গণপ্রজাতন্ত্রী বাংলাদেশ সরকার  
শ্রম ও কর্মসংস্থান মন্ত্রণালয়  
কলকারখানা ও প্রতিষ্ঠান পরিদর্শন অধিদপ্তর

ক্যাপ পর্যবেক্ষণের তথ্য

কারখানার নাম	শোনন সোরেটারস লিঃ
ঠিকানা	Plot-A-118. S-36, BSCIC, Konabari, Gazipur
কারখানার কোড	GZP309
কালার কোড	
মূল্যায়নের ধরণ: <a href="#">কাঠামোগত মূল্যায়ন</a>	পর্যবেক্ষণের তারিখ: ১২-০৪-২০২৩
১. পর্যবেক্ষণ

### সংযুক্তিসমূহ ( ৮ )

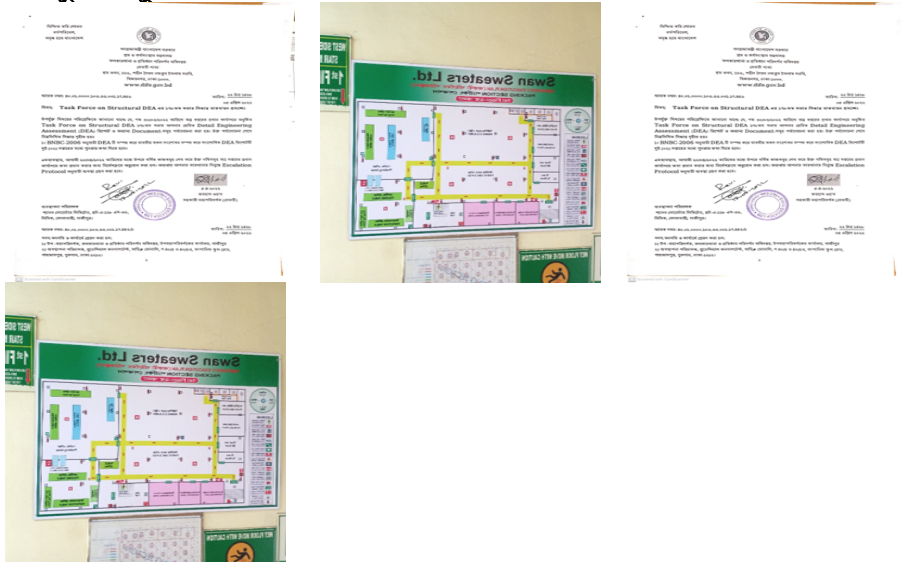
কার্যক্রম	Verify in-situ concrete stresses either by 100mm dia. cores or existing cylinder strength data for identified B6 columns.
সুপারিশের তথ্যসূত্র	
কারখানার কার্যক্রম	
অগ্রাধিকার	প্রযোজ্য নয়
চূড়ান্ত সময়সীমা	-
সংশোধিত সময়সীমা	০১-০১-১৯৭০
অগ্রগতির অবস্থা	সংশোধিত
মন্তব্য	09-April-2019: Core test results have been found on site with different name of the factory. No evidence of core cutting have been observed on site. 07-Nov-2019: Core test results have been found on site with different name of the factory. No evidence of core cutting has been observed on site. 04-Mar-2020: Core test report was found but factory name mentioned in core test report is not matched. Also, evidence of core cutting was not possible to verify due to plastering work. 19.10.2020: DEA report was submitted to DIFE for approval which covers the core test report. But the core test report states different factory name and no core cutting evidence was seen during inspection. 06-01-2021: Core test results have been found on site with different name of the factory. No evidence of core cutting have been observed on site. 10.08.2021: Core test results have been found on site with different name of the factory. No evidence of core cutting have been observed on site. 17.08.2022: Core test results have been found on site with different name of the factory. factory management says that, when the DEA work start & Core has been taken of the building then the factory name is Mega Fashion Wear Ltd. DEA Completion, return for correction & resubmission continue after a long time. in the mean time factory name is change by Shanon Sweater Ltd. Again after a same day factory change name by Swan Sweater Ltd. Also we verify core layout plan. core layout plan are matched with provide core layout plan. 12.04.2023: Completed.
